**ADDENDUM NO. 1**

**PROJECT NAME:** City Campus Utility Plant North Cooling Tower Replacement General Installation Contract Package

**UNL PROJECT NUMBER:** C028P241  
**BID INVITATION NUMBER:** 2247-13-7200

**CONSULTANT:** Lutz, Daily & Brain, LLC  
6400 Glenwood, Suite 200  
Overland Park, KS 66202

**DRAWING NUMBER:** 40213-COUP-NCT-E2  
**SHEET NUMBER:** 8

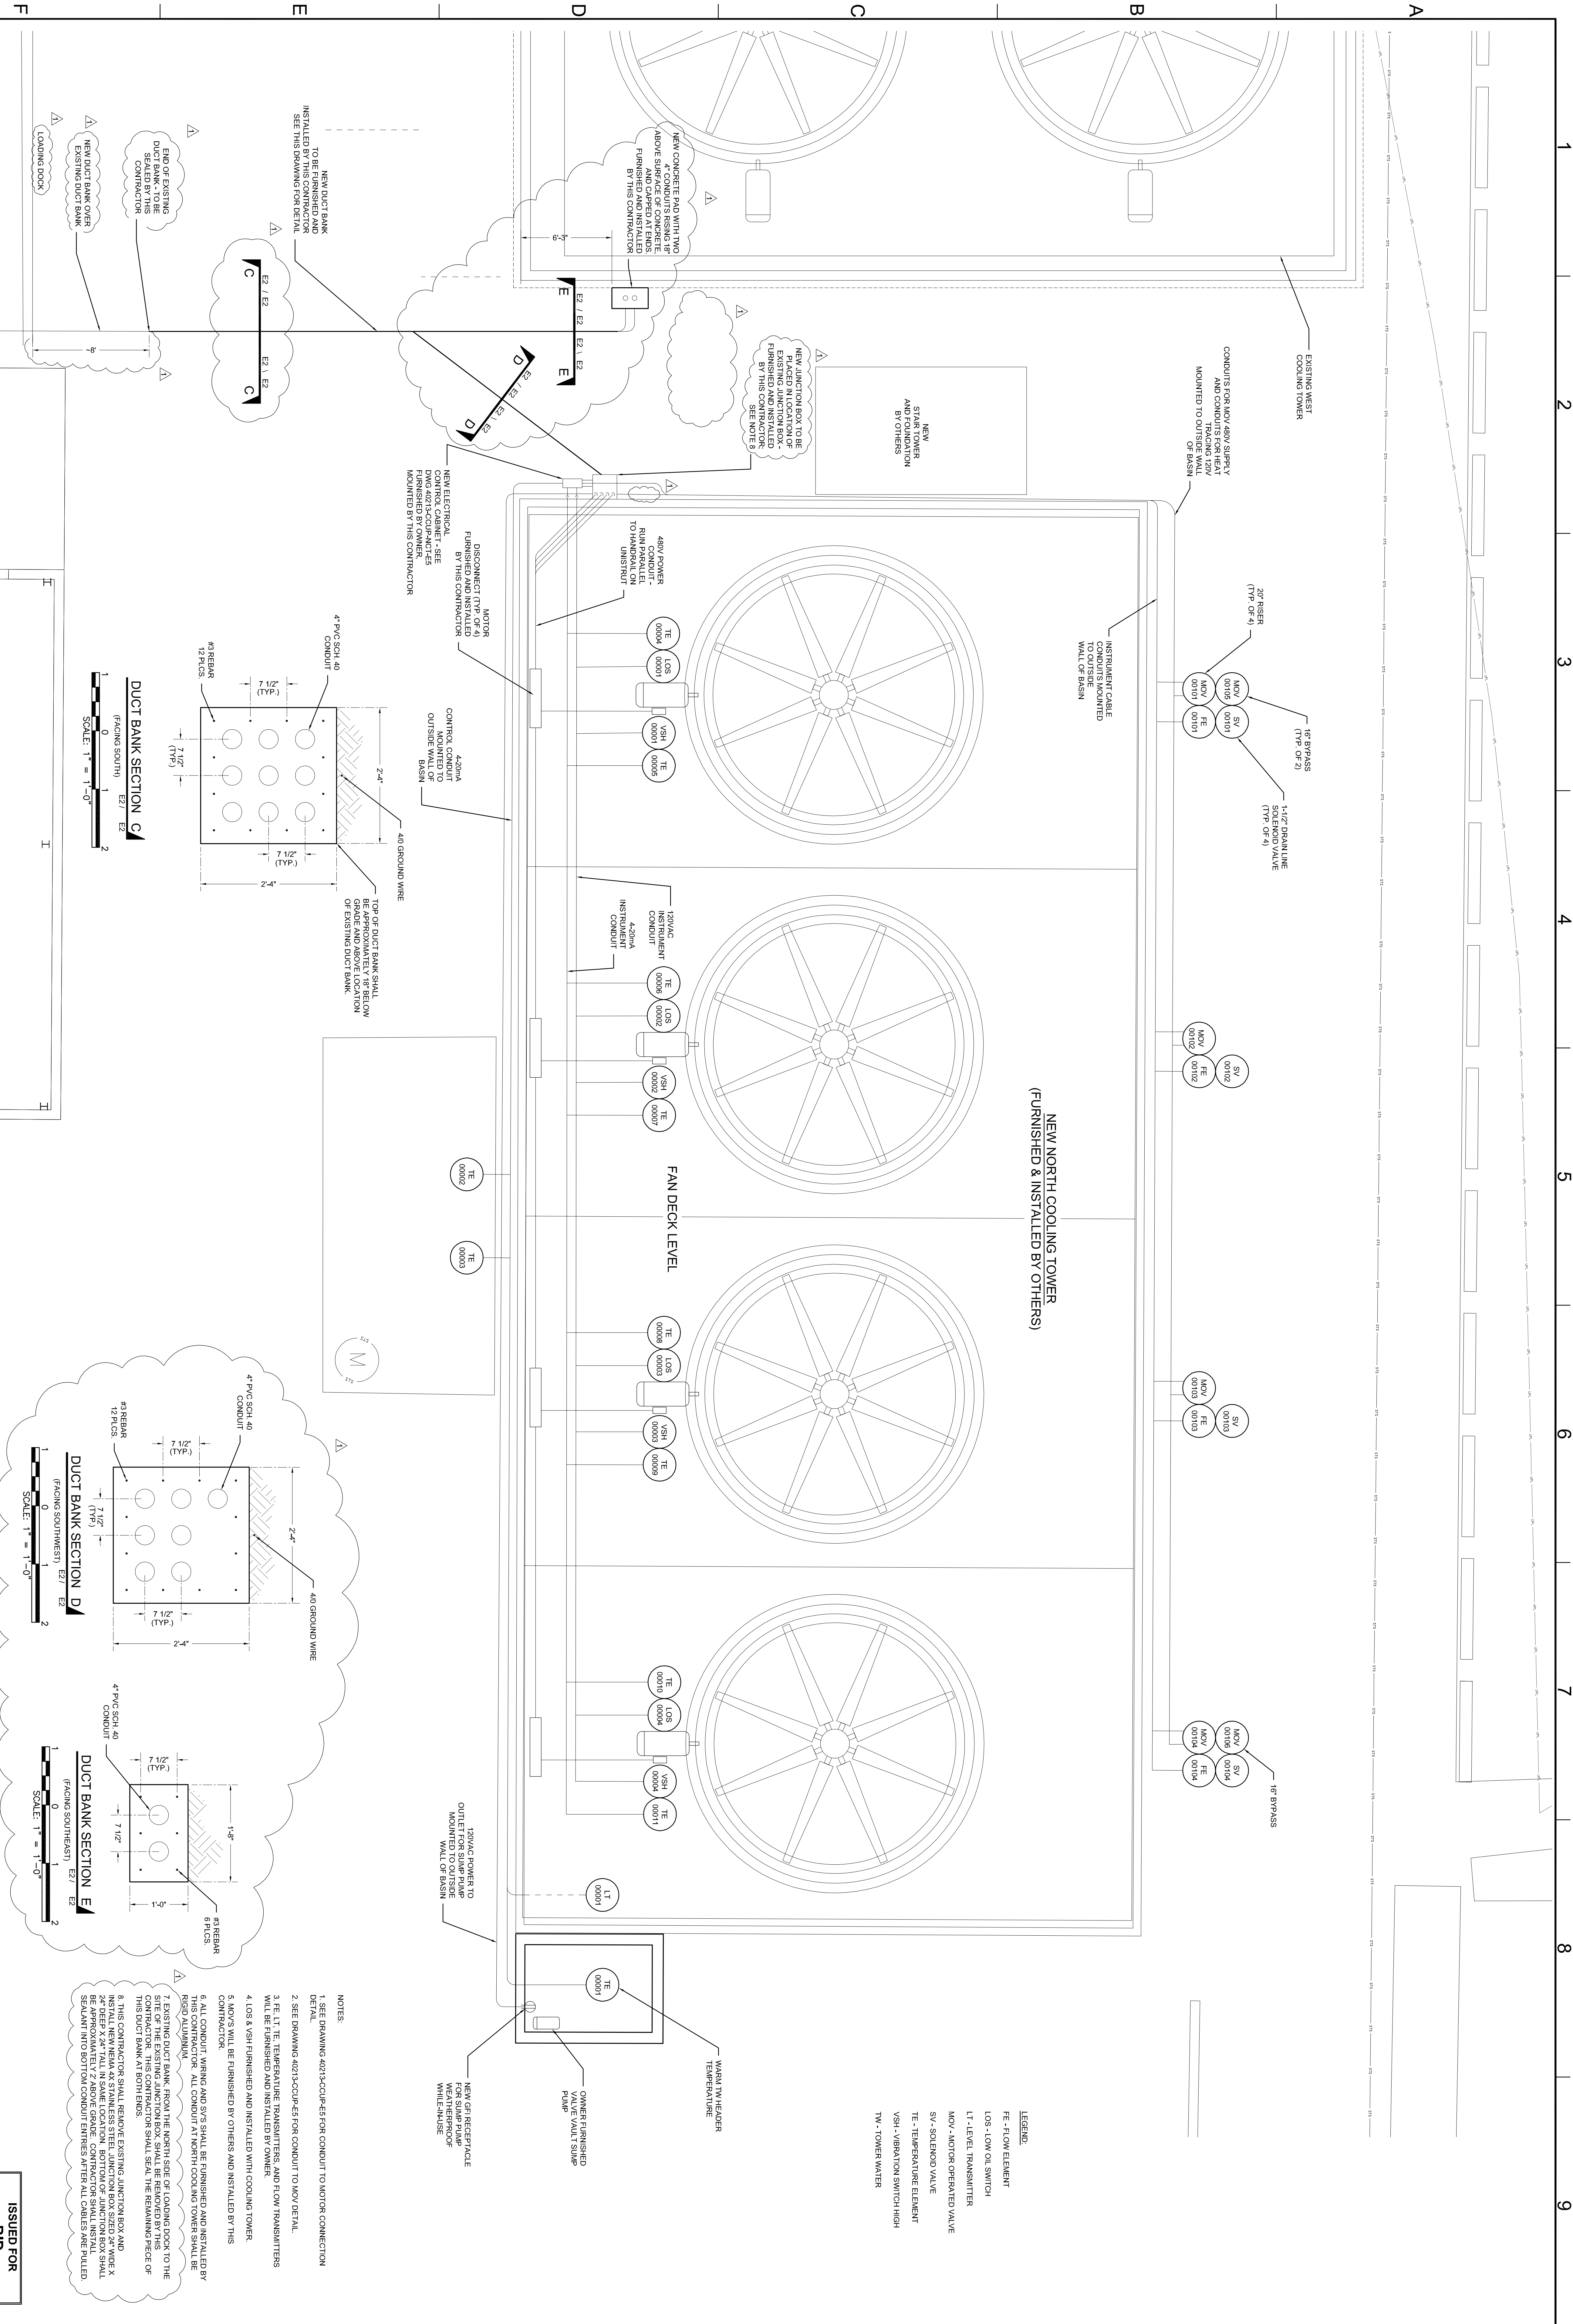
- Ductbank Section C: Revise ductbank configuration from 2 conduits wide x 4 conduits deep to 3 conduits wide x 3 conduits deep which changes the ductbank cross section from 1'-8" wide x 3'-0" deep to 2'-4" wide x 2'-4" deep with top of new ductbank being approximately 18 inches below grade.

- At a point in between the existing west and north cooling tower basins the duct bank will be split into two separate duct banks. One is to be 2 conduits wide by 1 conduit deep and will go to a point near the southeast corner of the west cooling tower basin. The other duct bank is to be 3 conduits wide by 2 conduits deep plus 1 conduit on top going near the southwest corner of the north cooling tower basin as shown on reissued drawing 40213-CCUP-NCT-E2.

- 13.1 Drawings 40213-CCUP-NCT-E2, E3 & E4: 480V Hoffman enclosure removed from plan views.
- 13.2 Drawing 40213-CCUP-NCT-E6:
  - Circuit P005 increases in length from 80' to 155'.

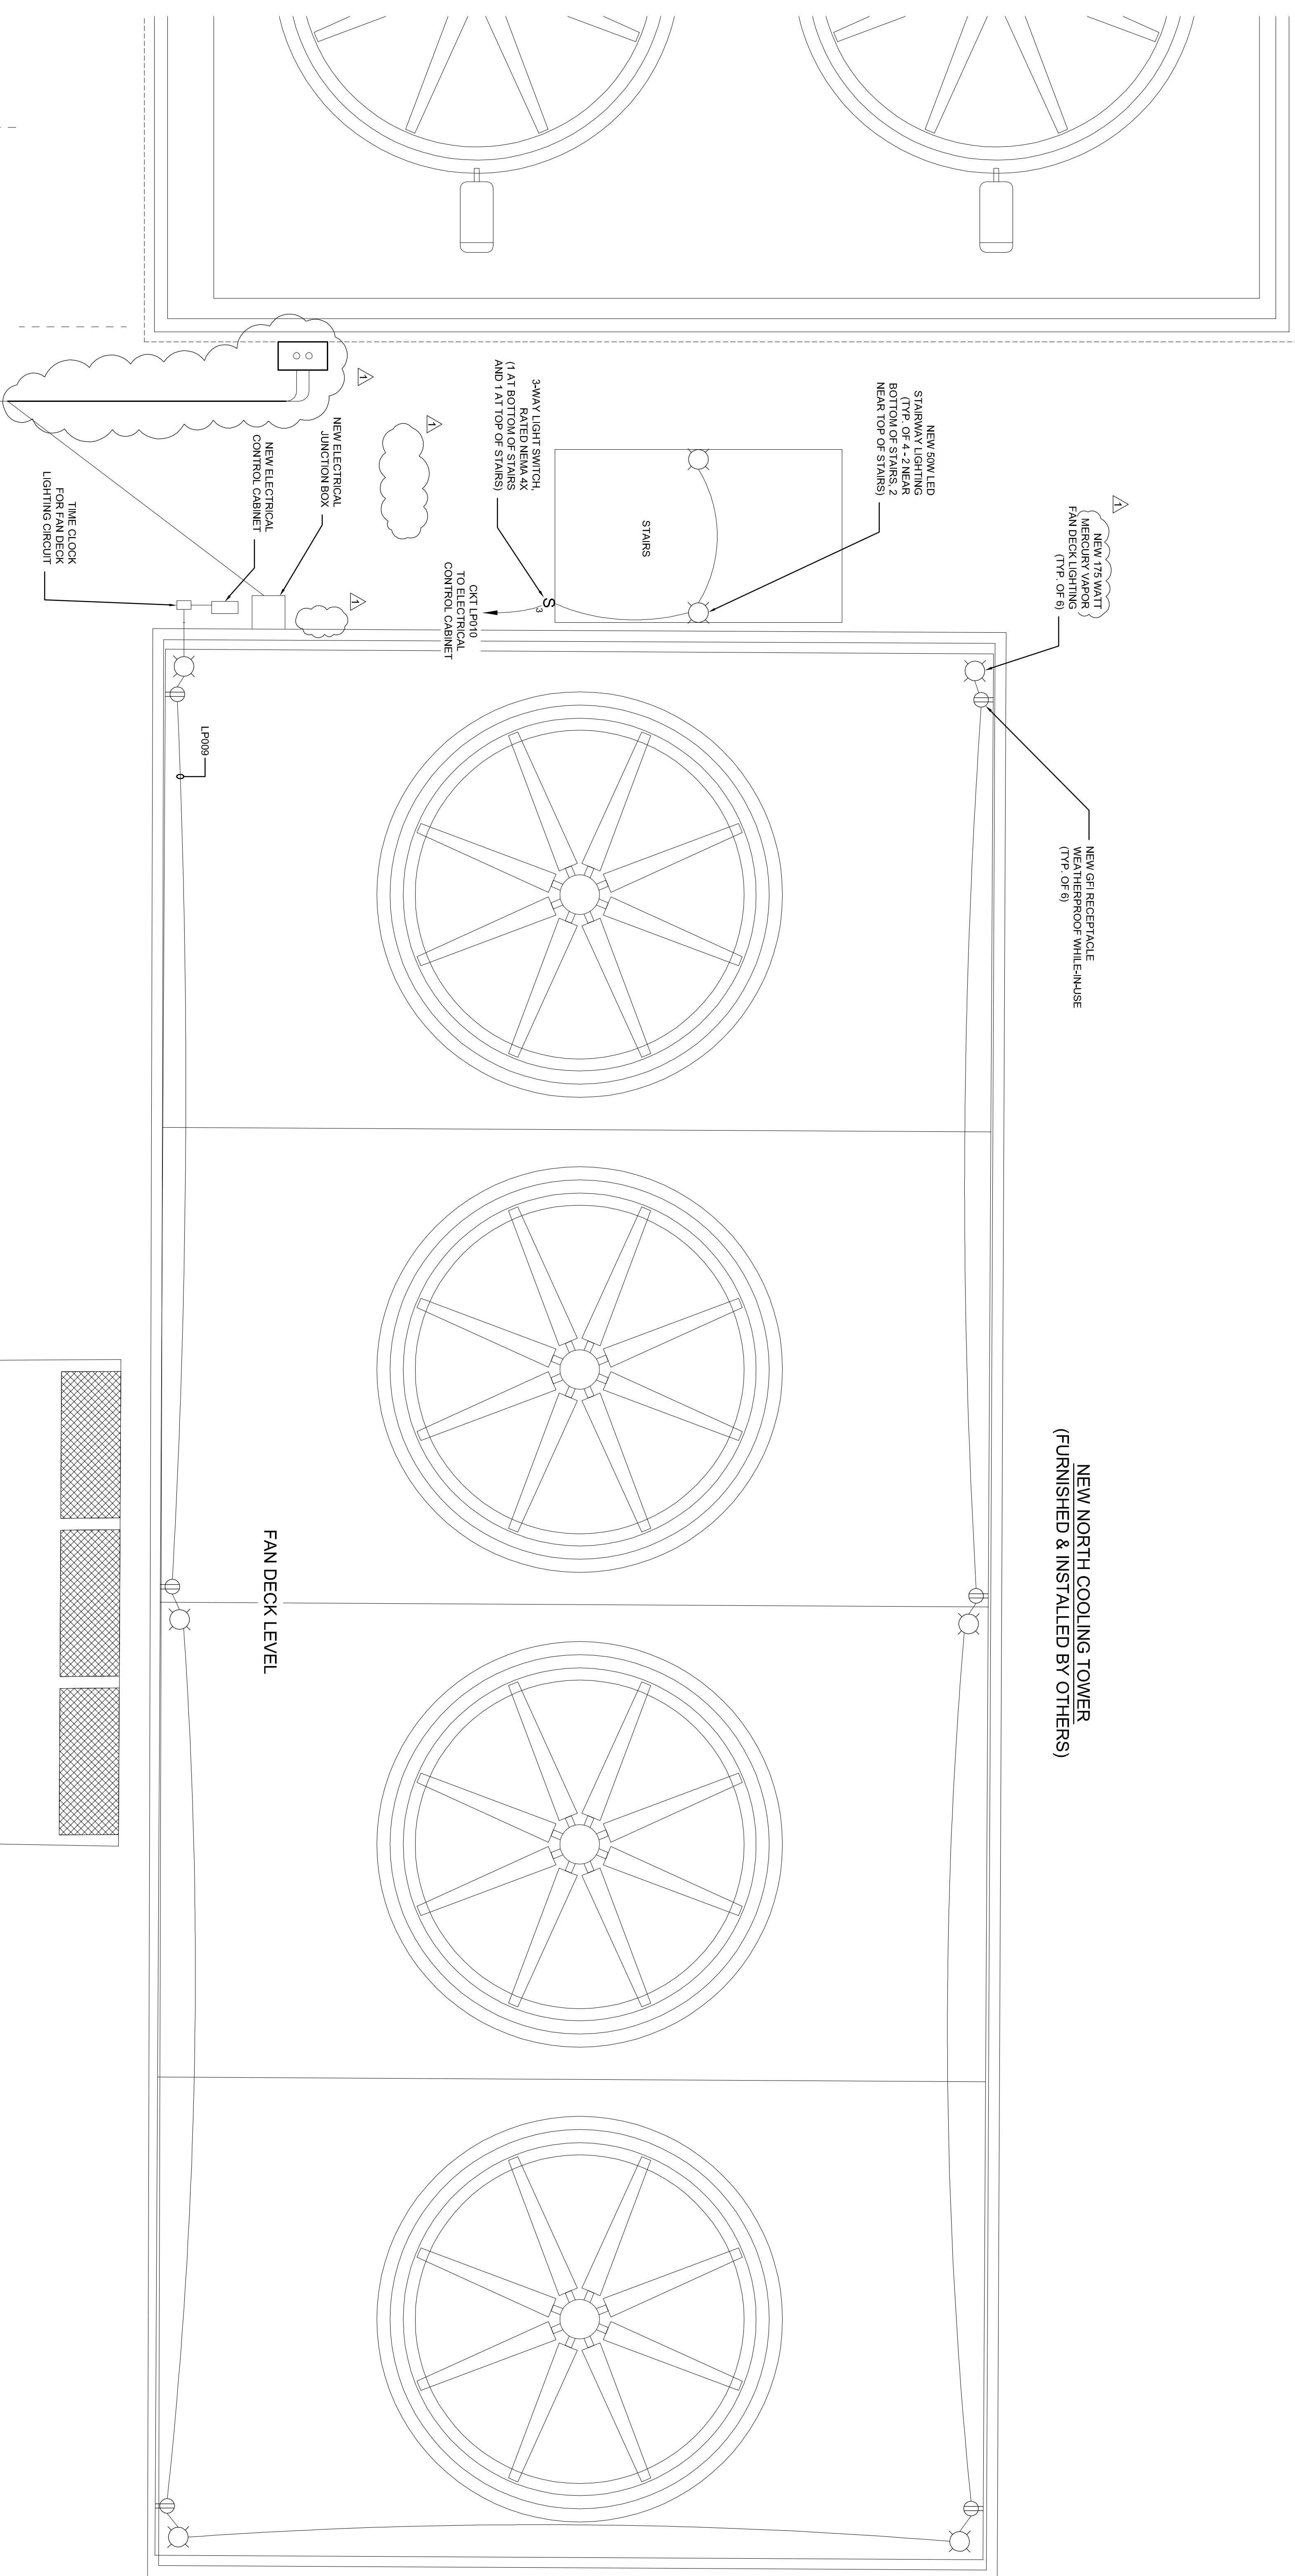
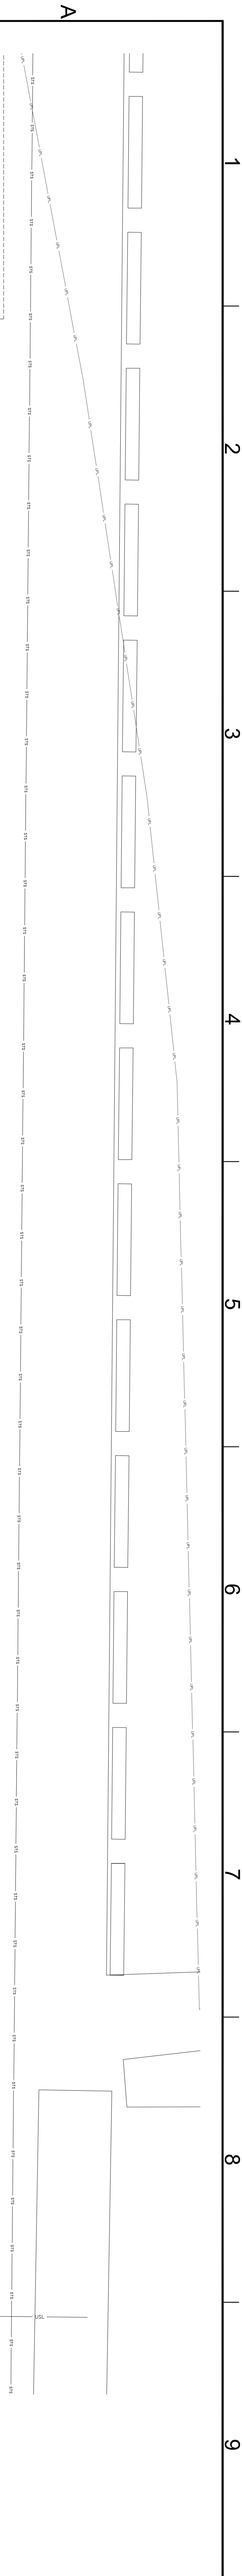
*Callout on Drawing 40213-CCUP-NCT-E4 shall change to read "175W mercury vapor".*
